McCune Ranch

PRELIMINARY PLAN

SP-18-006

COVER SHEET

ADJACENT PROPERTY OWNERS

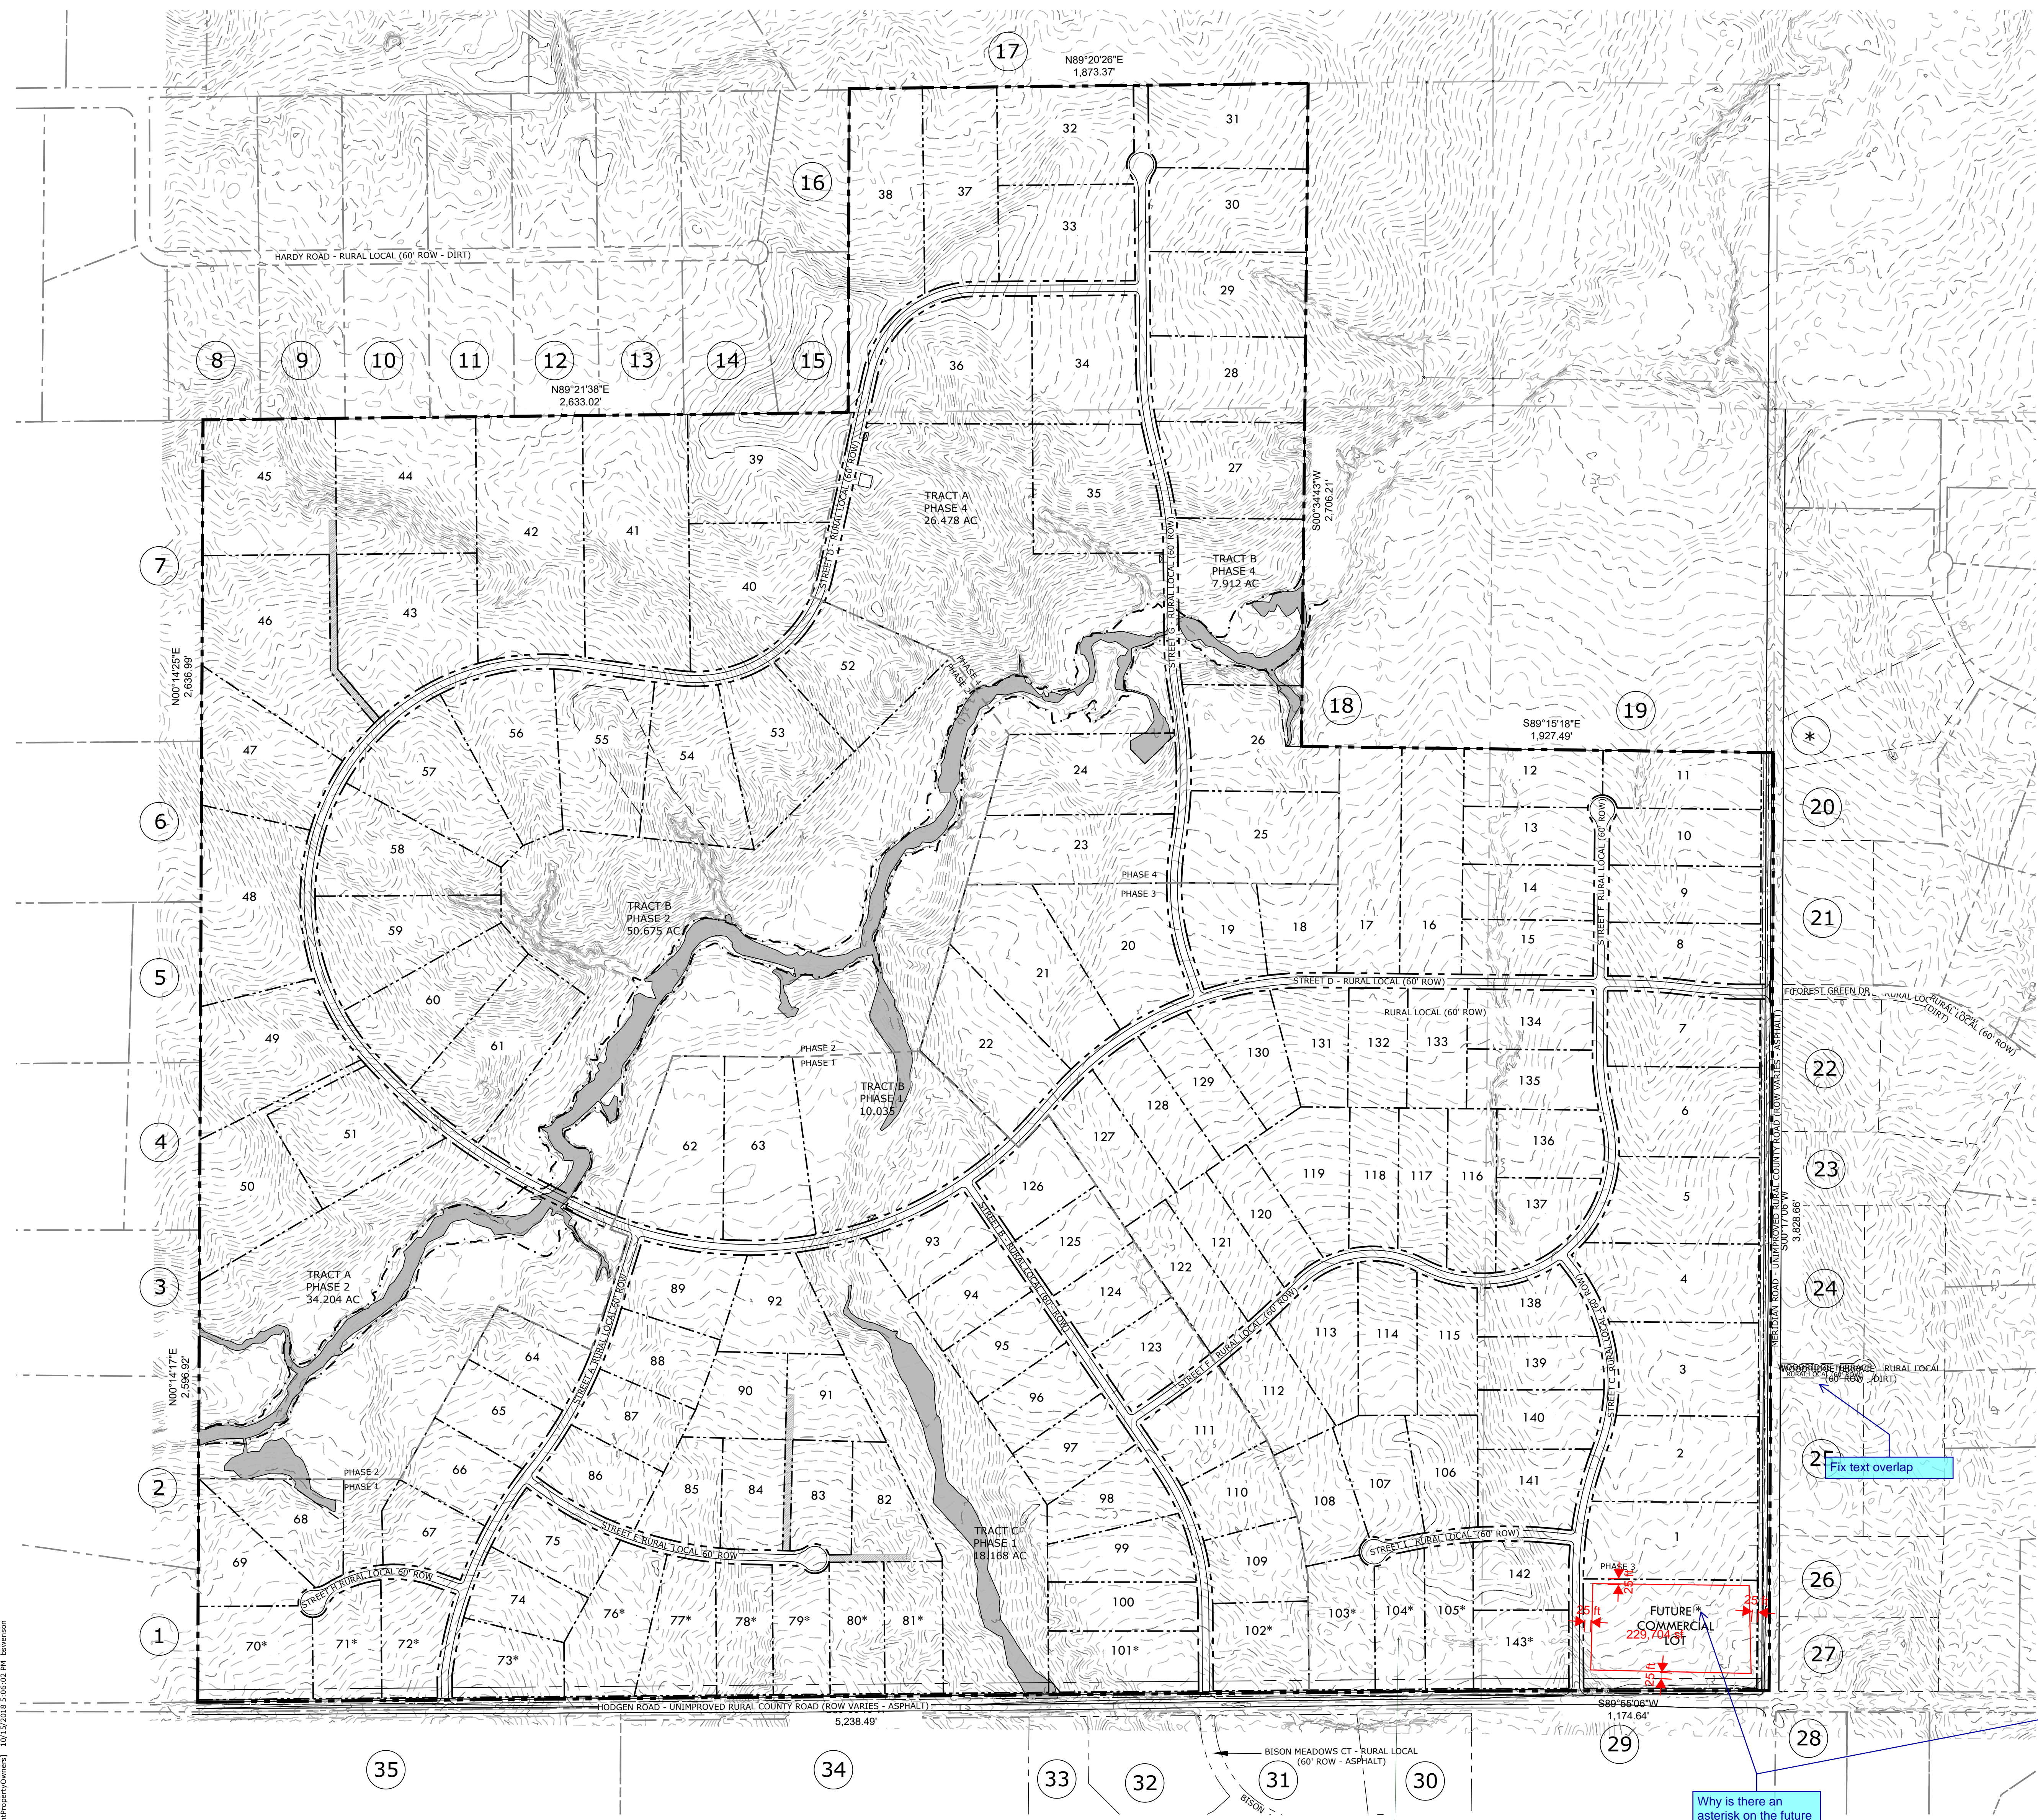
Fix text overlap

Why is there an asterisk on the future commercial Lot?

* on many lots that it should not be on
